REQUEST FOR COUNCIL ACTION

AGENDA SECTION: PUBLIC HEARINGS	ORIGINATING DEPT: PLANNING	ITEM NO. E-1
ITEM DESCRIPTION: Restricted Development Preliminary Plan #03-04 by Rochester Sand & Gravel Division of Mathy Construction. The applicant is requesting approval to establish a hot mix asphalt facility on property located east of TH 63, south of 60 th St. South and northeasterly of "Machinery Hill", within the Quarve Quarry pit. The applicant is requesting waiver of the Final Plan review.		PREPARED BY: Mitzi A. Baker, Senior Planner

RE: Restricted Development Preliminary Plan #03-04 by Rochester Sand & Gravel Division of Mathy Construction. The applicant is requesting approval to establish a hot mix asphalt facility on property located east of TH 63, south of 60th St. South and northeasterly of "Machinery Hill", within the Quarve Quarry pit. The applicant is requesting waiver of the Final Plan review.

South 63 Quarry	
ROCHESTER SAND & GRAVEL	Project ID #
Division of Mathy Construction Company	4915-17-02 KCM
618 Main Avenue North, Orono, WI 54651	Drawn By
	KMB 4/13/02
HMA Site Layout	Drawing No. 2

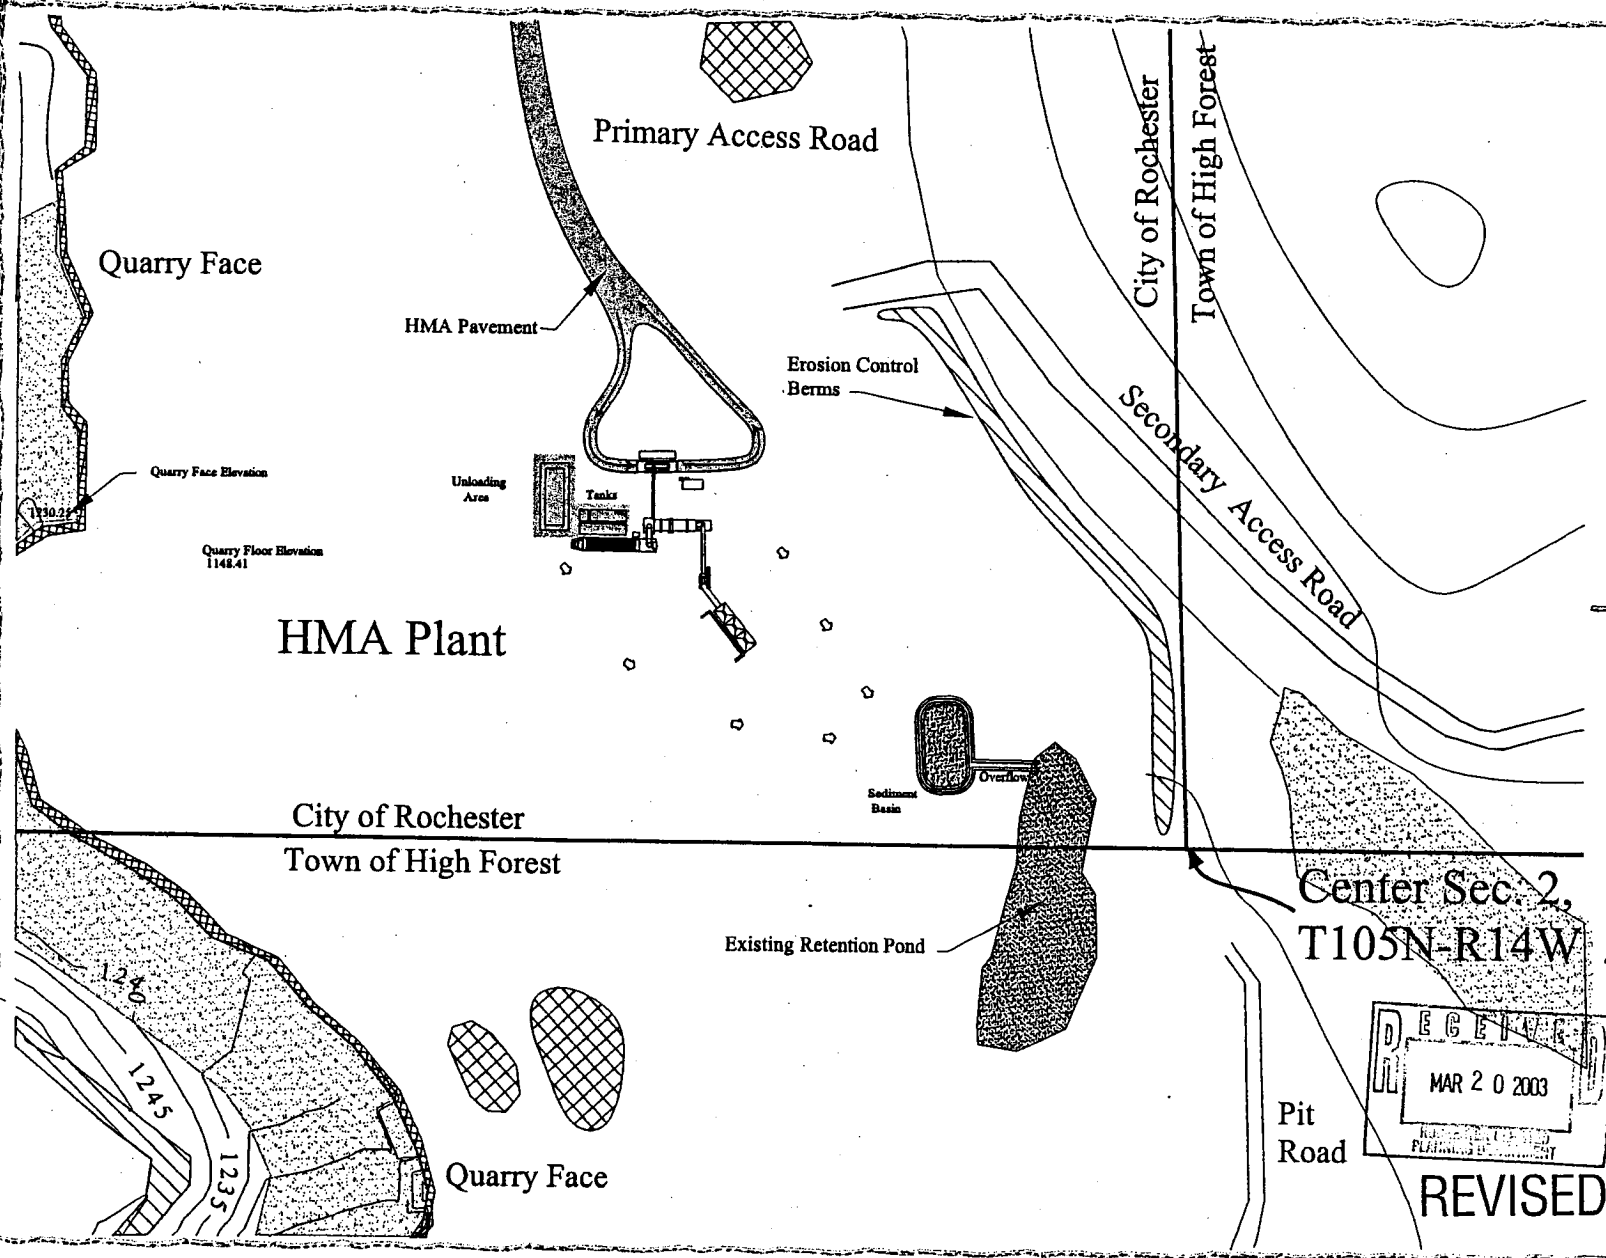
A layout of the proposed HMA plant is included in the attached materials provided by the applicant (Drawing #2). Detailed explanation of the plan, equipment, regulatory controls and monitoring is also included.

- h) **Internal Site Design:** *A layout of the proposed HMA plant is included in Drawing #2. From the HMA site, access will be available either to the east to St. Bridget Road/CR 20 or to the TH 63 accesses to the Quarry. The primary access is planned to be the north TH 63 access, which is located at the intersection of TH 63 and the 60th St. SW and east Frontage Road.*

1. ***A right turn lane and bypass lane will be required from CSAH 20, as required by Olmsted County Public Works.***
2. ***Import of materials for processing be limited only to that necessary for the hot mix asphalt facility.***
3. ***A grading and drainage plan shall be provided to Rochester Public Works and approved for paving the primary access road, constructing the sedimentation basin, and related grading necessary to provide positive drainage to the sedimentation basin.***
